From: Manoj Nathoo (AT)
Sent: Wednesday, 30 April 2025 9:38 am
To: Siobhan O'Donovan (AT)
Subject: FW: Project K - East St Design Change
Attachments: 3127079-100-TA-East St Optinoneering.pdf

From: Putri Kusumawardhani (AT) <Putri.Kusumawardhani@at.govt.nz>
Sent: Wednesday, 19 February 2025 4:02 pm
To: Sophia Wang (AT) <Sophia.Wang@at.govt.nz>; Mitra Prasad (AT) <Mitra.Prasad@at.govt.nz>
Cc: Manoj Nathoo (AT) <Manoj.Nathoo@at.govt.nz>; Vaughn Scott (AT) <Vaughn.Scott@at.govt.nz>
Subject: RE: Project K - East St Design Change

Thank you for sharing the new and initial designs of East St as part of Project K. Kindly find my comment below:

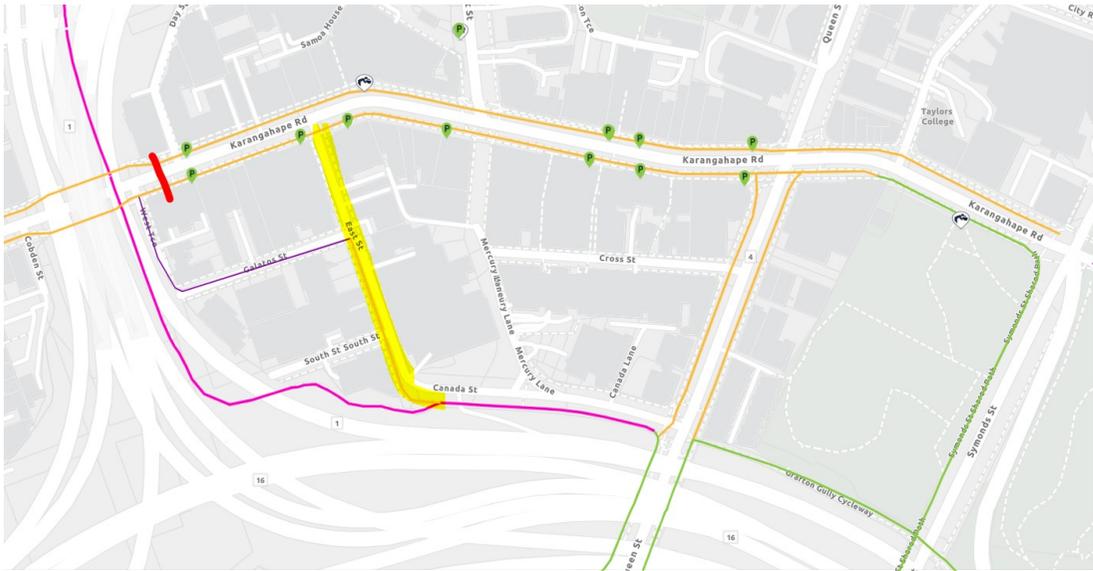
Firstly, regarding the overall cycling network and movement, I noticed that the new proposal attempts to maintain the connection to and from Galatos St-West Terrace as sharrow environment. However, I could only spot the sharrow on the northbound of East St (uphill), no sharrow proposed on southbound.

I strongly recommend having East St as a continuous cycle facility with sharrow markings extending up to the K'Road cycleway. This will help create a more cohesive cycling environment. [@Mitra Prasad \(AT\)](#) could I check current cycling movement and operational aspects on East St with you? I observed that West Terrace is not always clear due to loading and turning head movements, which create pinch points (see image below). Extending the sharrow environment on East St would help distribute the cycle movement more effectively and align with the location of the crossing (see red line) for accessing the opposite cycleway eastbound.

Current facility (quite street)

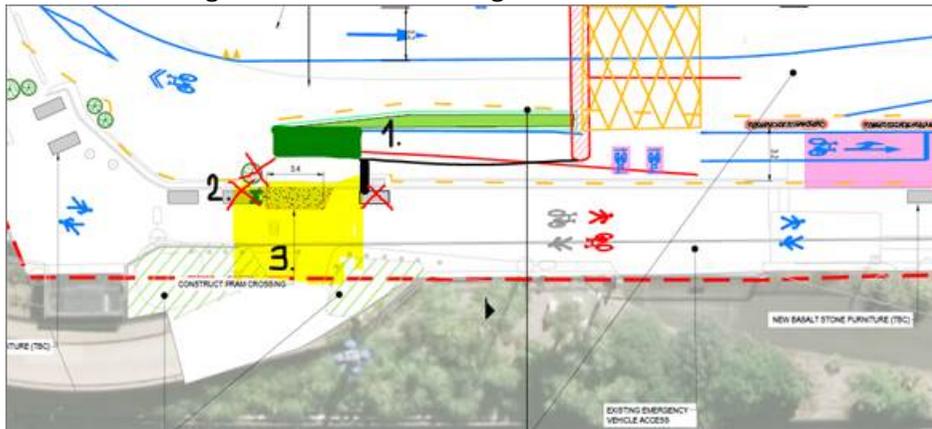
- Sharrow marking needs to reflect the agreement on the above conversation

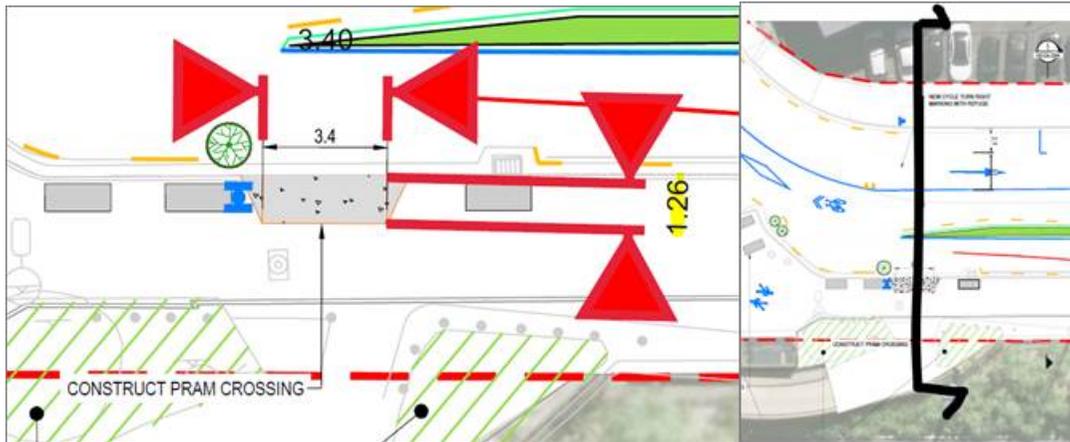
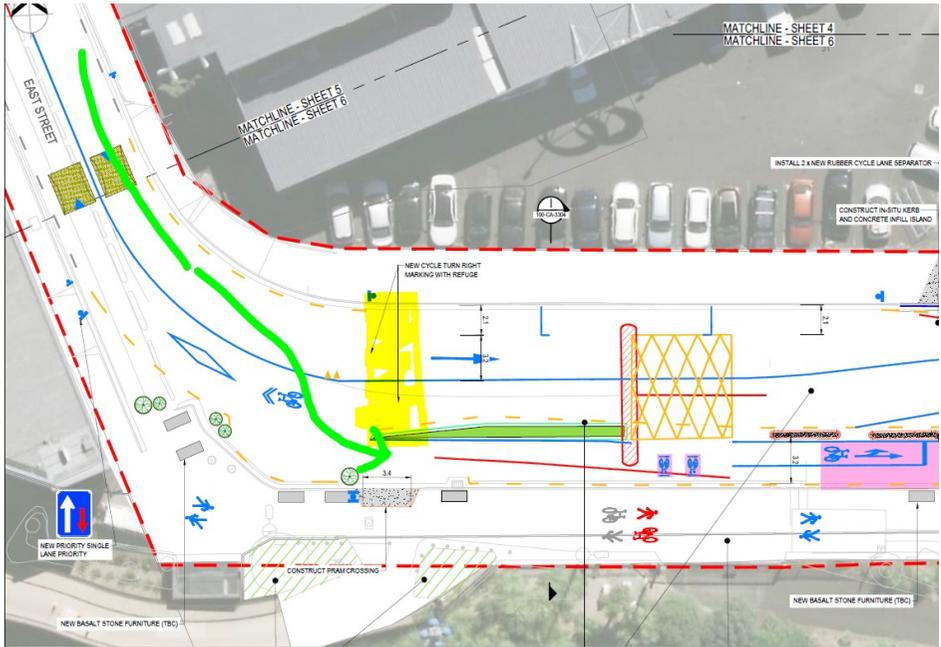
1. Cycle way marking (with arrow) to be provided, current proposal does not clearly show the expected cycle movement. Alternatively, consider adding limit lines on the cycleway with left-turn and straight arrows.
 2. It is crucial to ensure that there is no street furniture around the maneuvering area, and the 90-degree turning clearance area should be free from vertical features.
 3. The yellow area here will be an extension of the SUP from Light Path, so the design treatment needs to reflect this.
- Proposed pram crossing should comply with accessible gradient 5% (max.8.3%), as the proposed 1.26m depth will not meet the required gradient. Cross section to be provided for Canada St-pram crossing-Light Path.

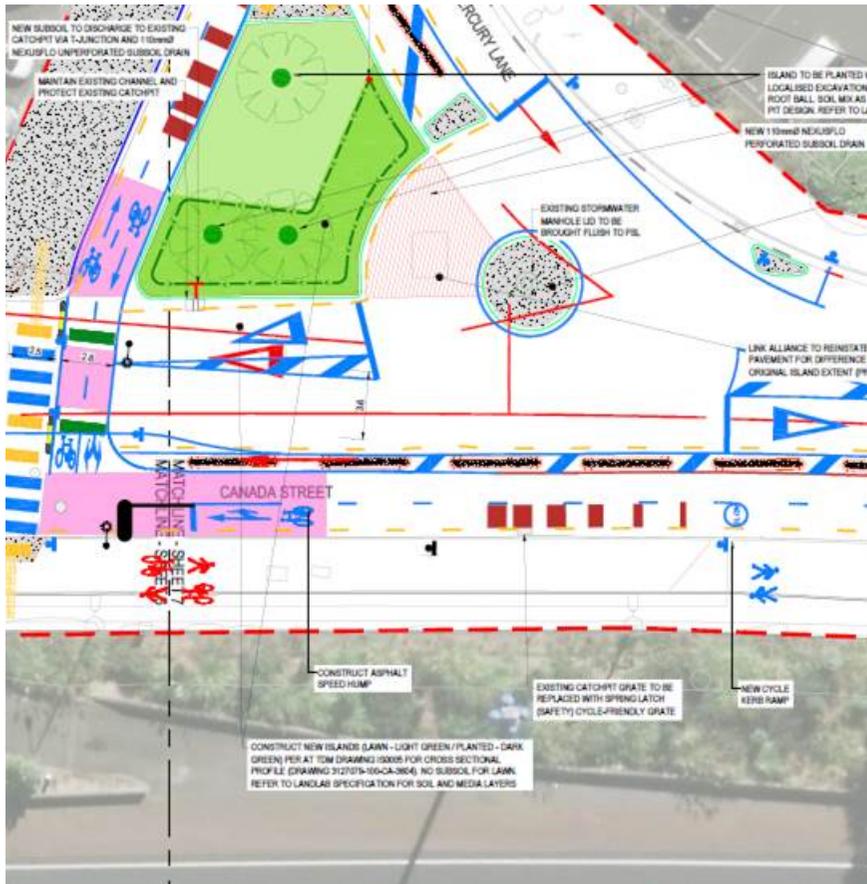
- Expect people on bikes to make entry maneuvers into the separated cycleway on Canada St (see the green line). The sharrow environment should start at the yellow area; therefore, sharrow marking treatment is needed here. Please refer to the reference image from another location, showing sharrow markings with right/left arrows.

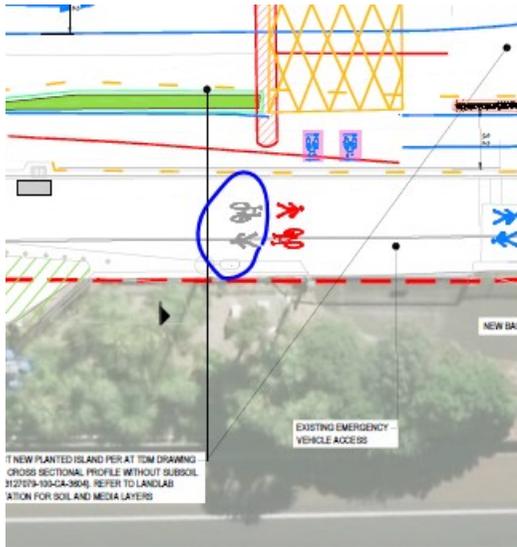
- The limit line can be brought closer, as indicated by the black line.
